Executive Director's Recommendation

Commission Meeting: April 2, 2026

PROJECT New Stadium at RFK Campus 2400 East Capitol Street, NE Washington, DC	NCPC FILE NUMBER 8721
SUBMITTED BY Mayor of the District of Columbia, RFK Stadium Project Management Office	NCPC MAP FILE NUMBER 8.40(38.00)46185
REVIEW AUTHORITY District Projects Outside the Central Area per 40 U.S.C. § 8722(b)(1)	APPLICANT'S REQUEST Approval of preliminary site and building plans
	PROPOSED ACTION Approve preliminary site and building plans with comments
	ACTION ITEM TYPE Staff Presentation

Approves preliminary site and building plans for a proposed new stadium and surrounding site improvements on the Robert F. Kennedy (RFK) Memorial Stadium Campus, located in Washington, DC.

Elevations and Height Comparison

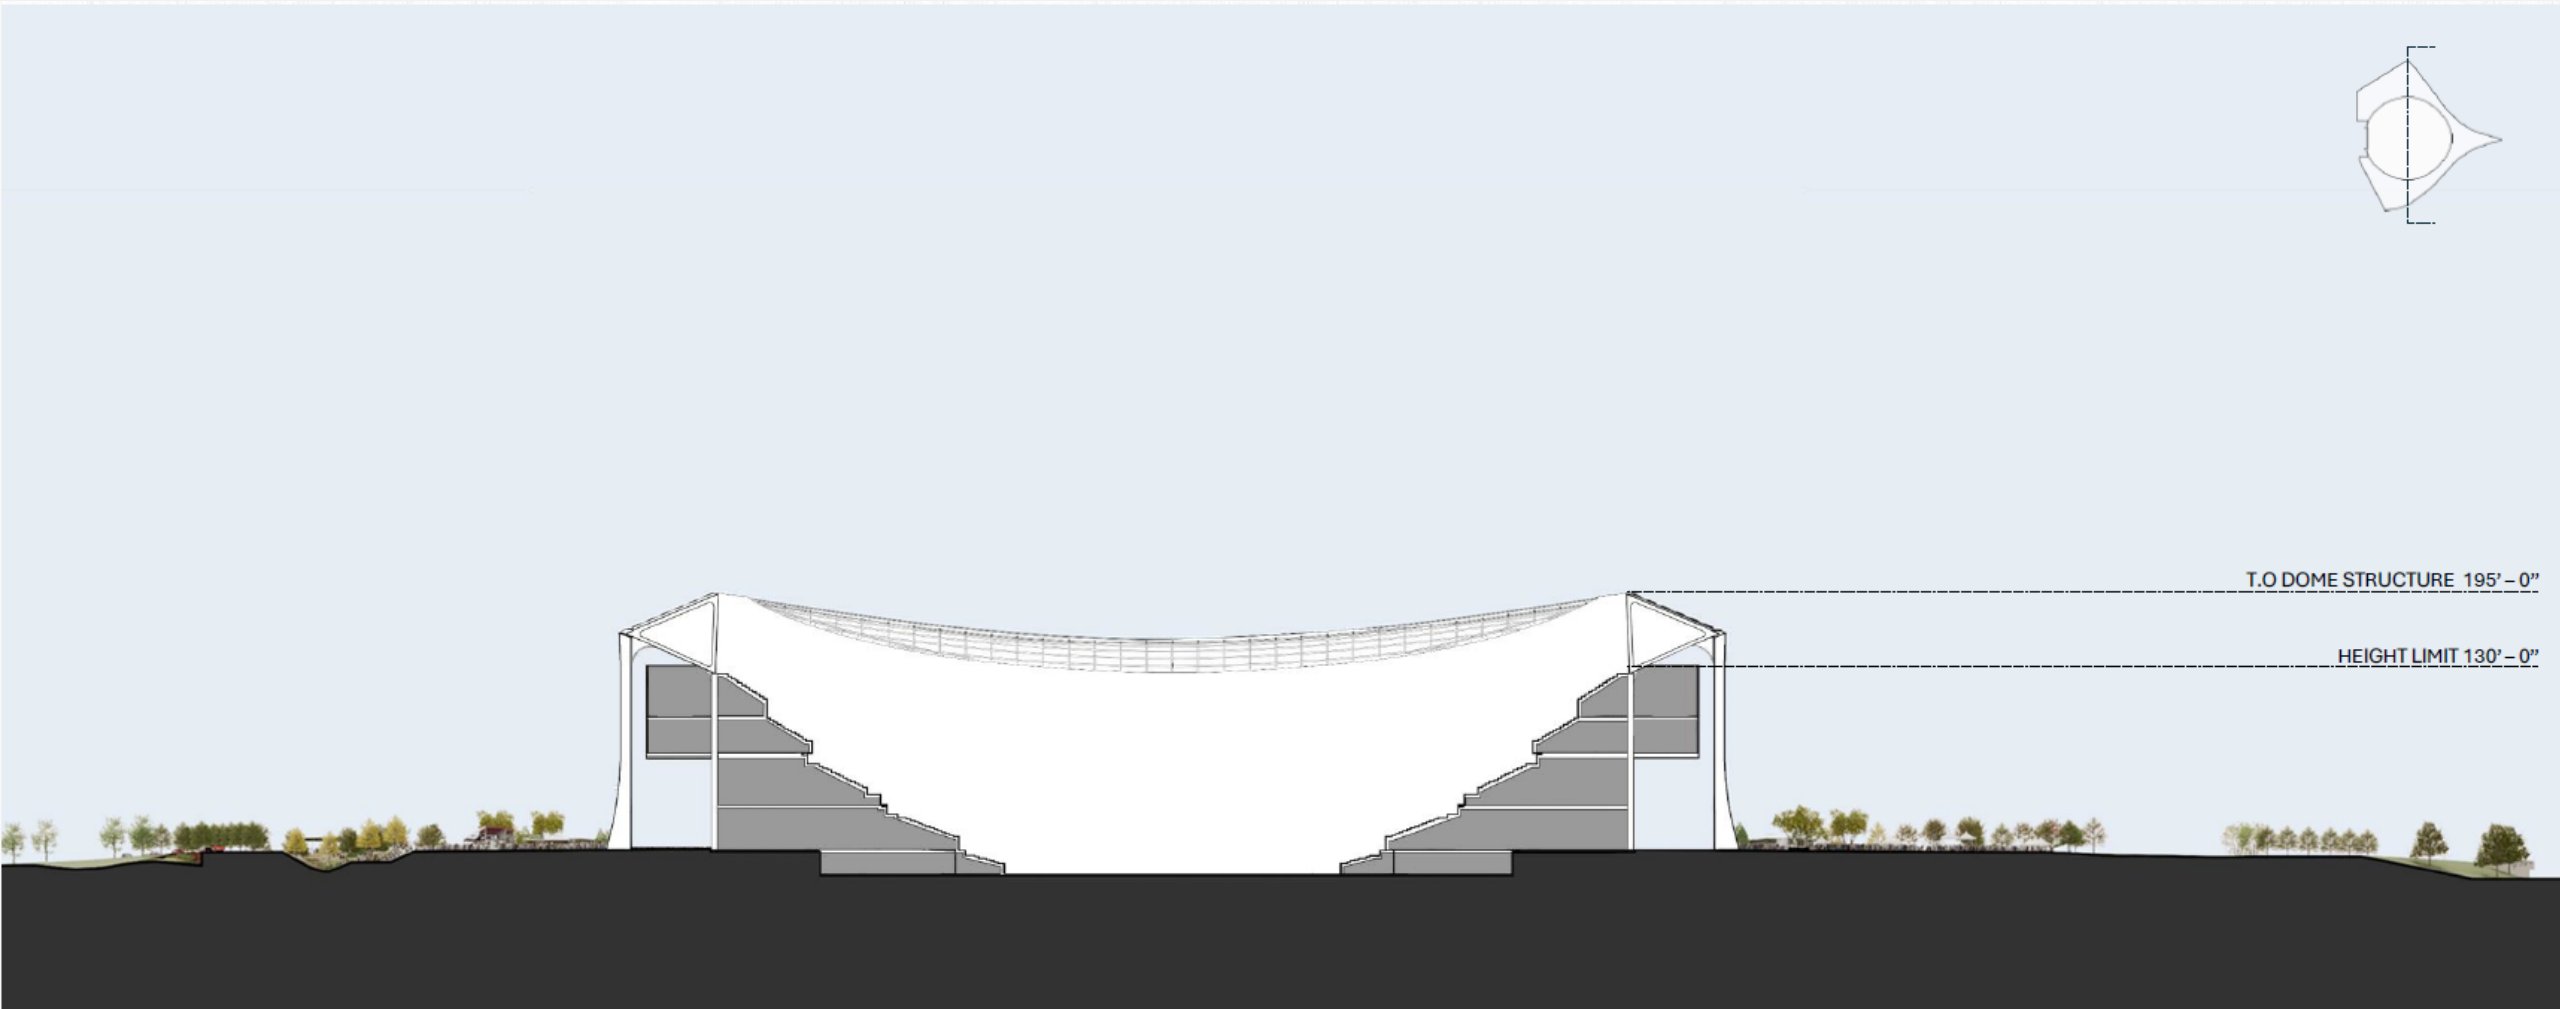
The Commission requested additional information about the stadium height and conformance with the Height Act. The 1910 Height of Buildings Act sets building height limits in the District and permits the stadium to be constructed to a height of 130 feet with a dome to extend above that height. The proposed full stadium height including the roof dome is 195 feet from the measuring point at the level of the sidewalk opposite the middle of the front of the west entry to the stadium. The District of Columbia Zoning Administrator confirmed the proposed stadium complies with the Height Act and issued a formal determination on December 31, 2025. The determination letter is attached to this report, along with explanatory diagrams from the design team.

- The District's Zoning Administrator made a final determination that the stadium design complies with the Height Act on December 31, 2025. The determination letter is attached to this report.

For the reasons stated above, I have determined that the current conceptual stadium design, as depicted on the attached Plans, complies with the Height Act. If plans for the stadium submitted with the building permit application are consistent with the Plans, then the plans will be considered compliant with the Height Act.

Column Details and Spacing

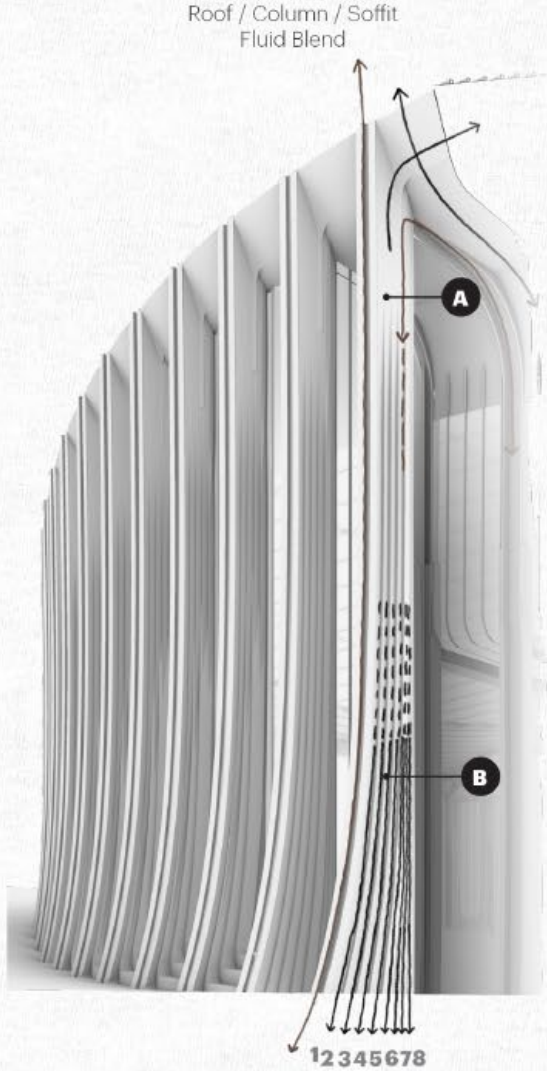
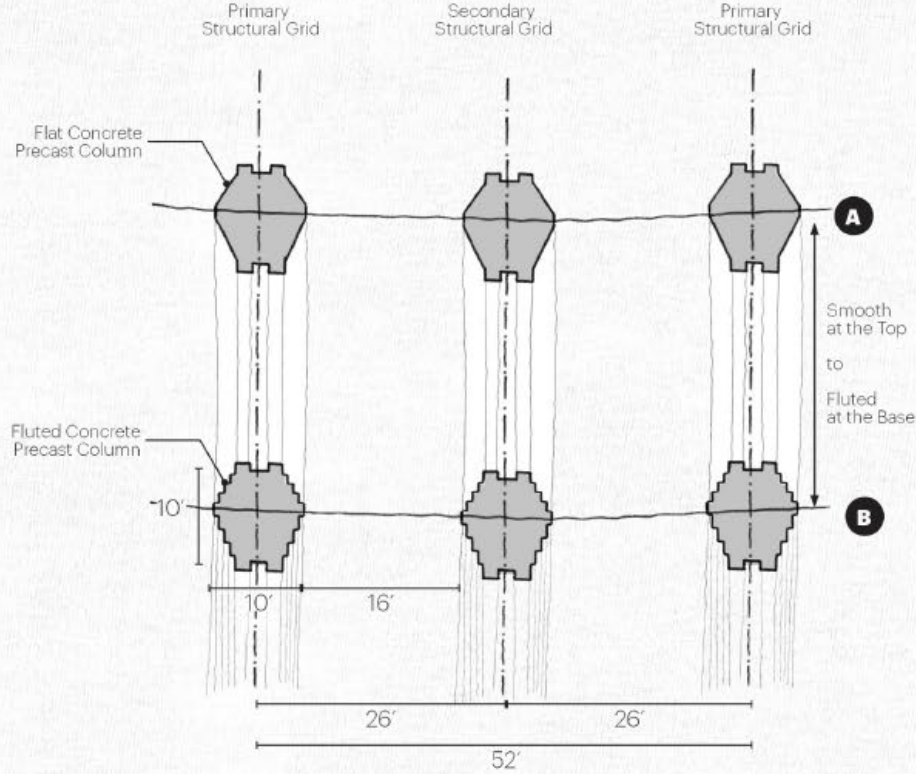
Notes that as requested at concept plan review, the column spacing and design have been further detailed. In reference to classical fluted columns, eight flutes are articulated at the base of each of the stadium's columns blending into a solid roof support symbolizing the eight Wards of the

At concept plan review the Commission also requested further information regarding the proposed column spacing and recommended further refinements to the design to reflect historical precedents. In reference to classical fluted columns, eight flutes are articulated at the base of each of the stadium's columns blending into a solid roof support symbolizing the eight Wards of the District united into one. The proposed column spacing is required structurally to support the stadium roof, with the primary structural grid of concrete ribs spaced every 52 feet on center and the intermediate secondary structural grid every 26 feet on center.

District united into one. The proposed column spacing is required structurally to support the stadium roof.

Lighting

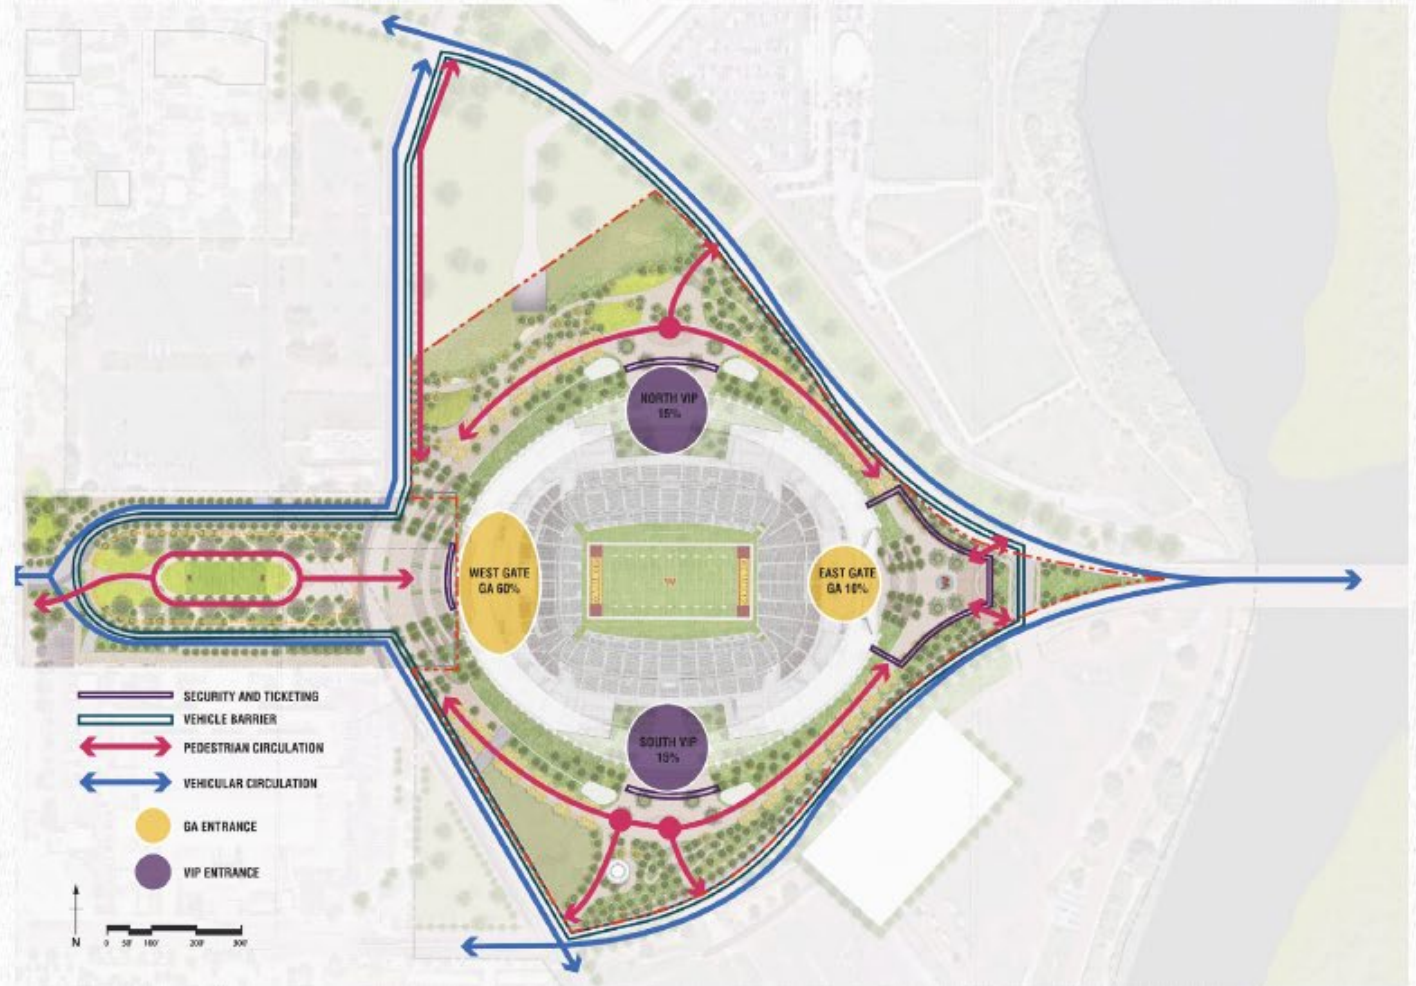
- Proposed exterior lighting levels in comparison to the U.S. Capitol Building and Washington Monument to ensure these structures remain the most prominent features in the nighttime skyline as outlined in Comprehensive Plan policy UD.B.1.5.
- The type, locations, size, and design of planned stadium exterior graphics such as significant signage, display screens, and projections, if proposed. The design should aim to balance entertainment needs with the public realm's overall visual character and not detract from other sites of civic importance as outlined in Comprehensive Plan policy UD.B.3.11.

Regarding lighting, graphics, and digital signage, the Comprehensive Plan discusses the need to balance the District's commercial and civic presence in and around the monumental core. The Commission recommended that as the stadium design is developed, the applicant study exterior

Perimeter Security

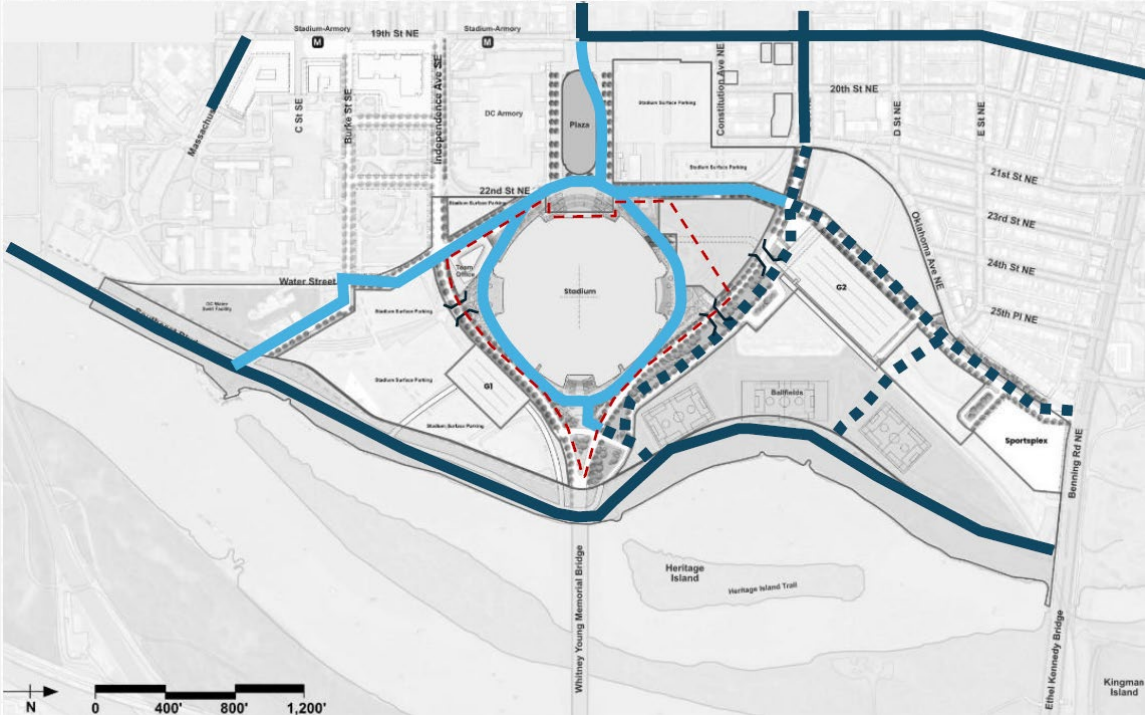
- Planned stormwater facilities on the stadium site that will be visible to the public;
- Permanent kiosks and pavilions proposed around the stadium grounds; and
- Permanent perimeter security elements such as bollards and barriers.

Recommends that as the design of permanent perimeter security elements are developed their form and materials should respond to the architectural and landscape context in which they are located and complement and aesthetically enhance the character of the stadium grounds as guided by Urban Design Element policy UD.C.3.8.

Day One Parking

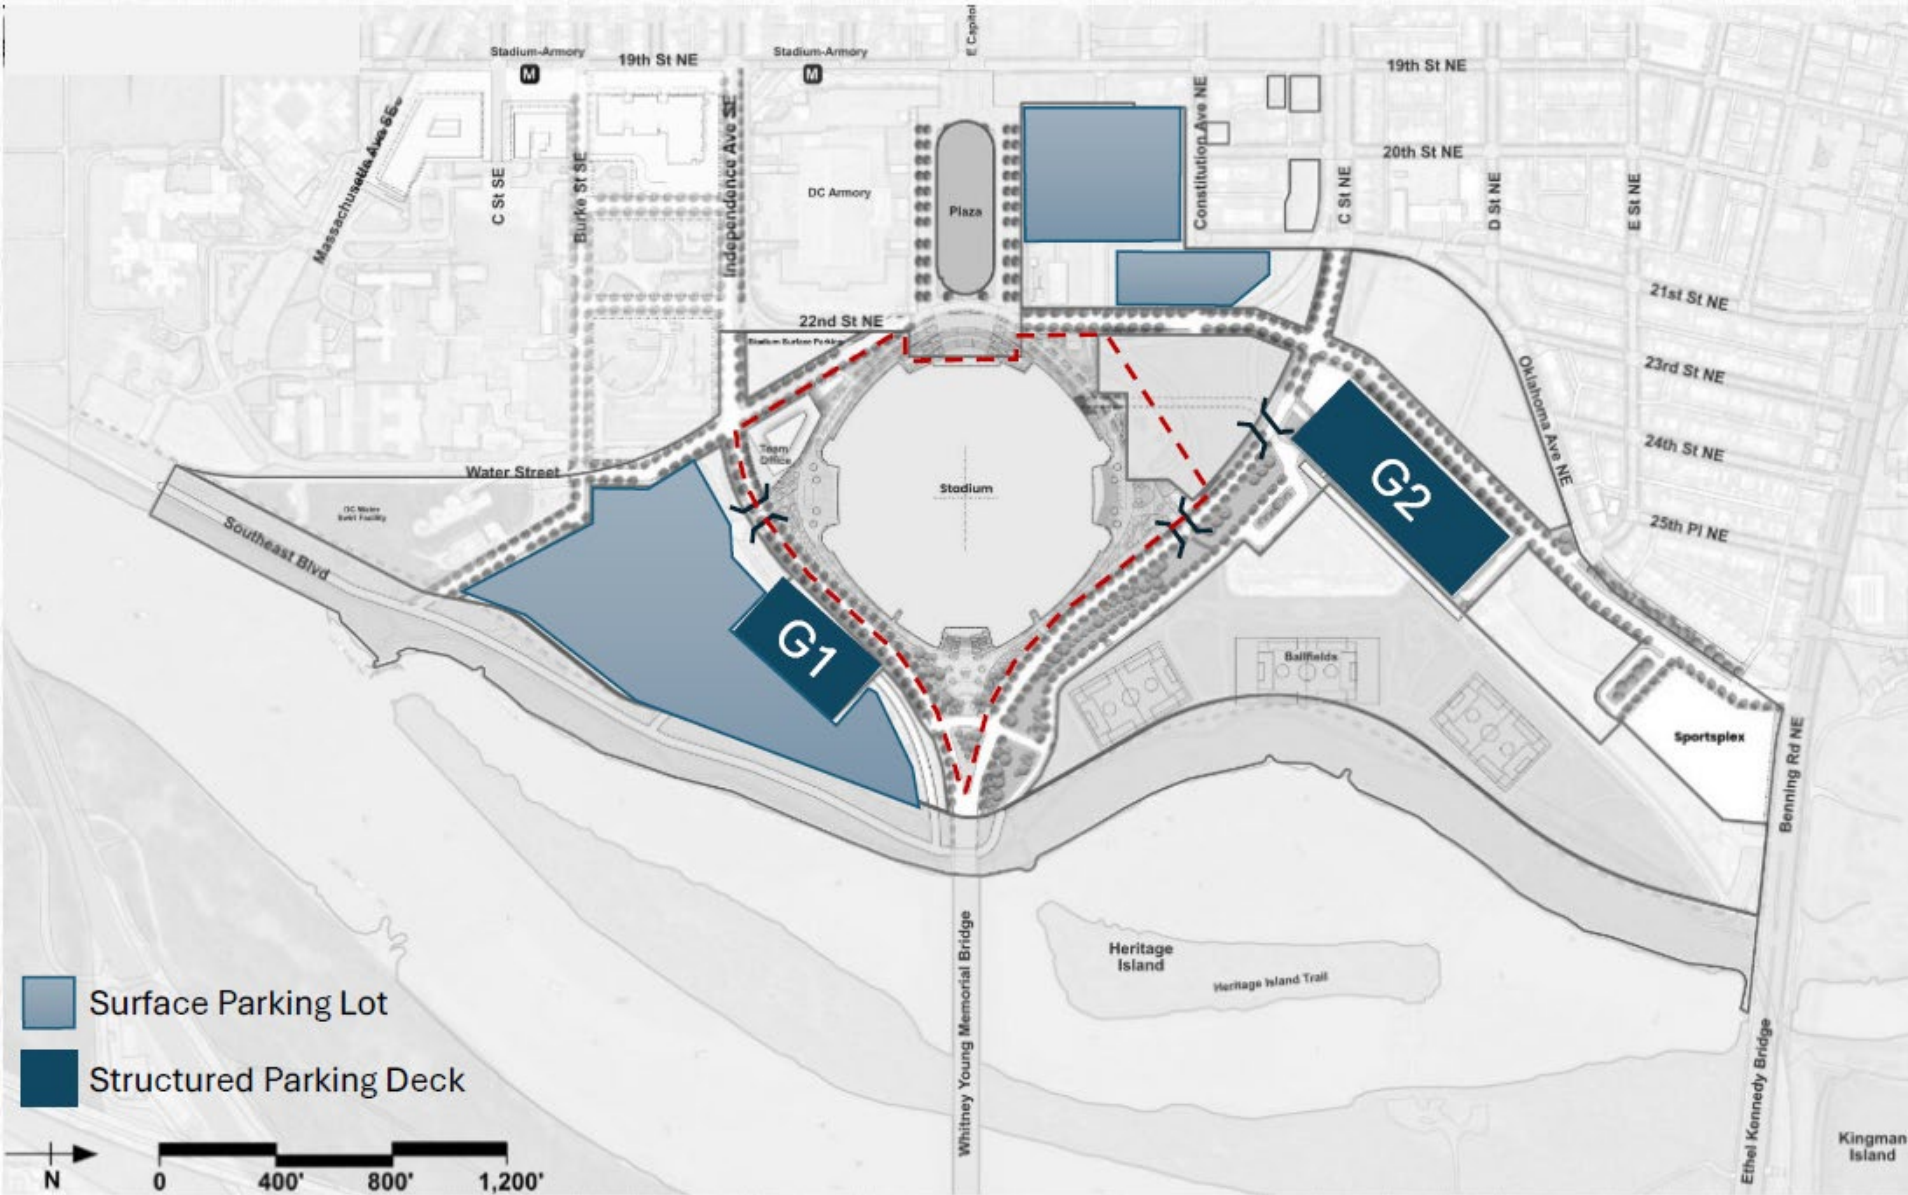
- Alternative orientations for the G1 and G2 garages to reduce visual impacts of views to the stadium and from adjacent neighborhoods while continuing to be in proximity to the pedestrian tunnels and highway access; and
- Lower garage heights, particularly for the G2 garage near the Kingman Park neighborhood, and/or phasing of garage upper floors as surrounding surface lots are developed; and
- Active uses lining the ground floors of the garages to improve the pedestrian experience and create opportunities for community serving uses, as these will be the only adjacent development in early phases.

The overall parking strategy and information on the design of proposed parking garages G1 and G2 were requested by the Commission at concept review. On opening day, the split between structured and surface parking spaces will be approximately 75% structured and 25% surface and the total number of parking spaces will not exceed 8,000. Additional structured parking may be incorporated as part of the campus redevelopment, if needed, as the surface parking lots are removed. The submission notes that the planned maximum height for parking garages G1 and G2 is 110 feet to provide the necessary number of parking spaces required for stadium opening. The garages are outside the stadium site under current Commission review; however, staff recommends the **Commission request the applicant evaluate the following as part of any future parking garage submissions:**

- **Alternative orientations for the G1 and G2 garages to reduce visual impacts of views to the stadium and from adjacent neighborhoods while continuing to be in proximity to the pedestrian tunnels and highway access; and**
- **Lower garage heights, particularly for the G2 garage near the Kingman Park neighborhood, and/or phasing of garage upper floors as surrounding surface lots are developed; and**
- **Active uses lining the ground floors of the garages to improve the pedestrian experience and create opportunities for community serving uses, as these will be the only adjacent development in early phases.**
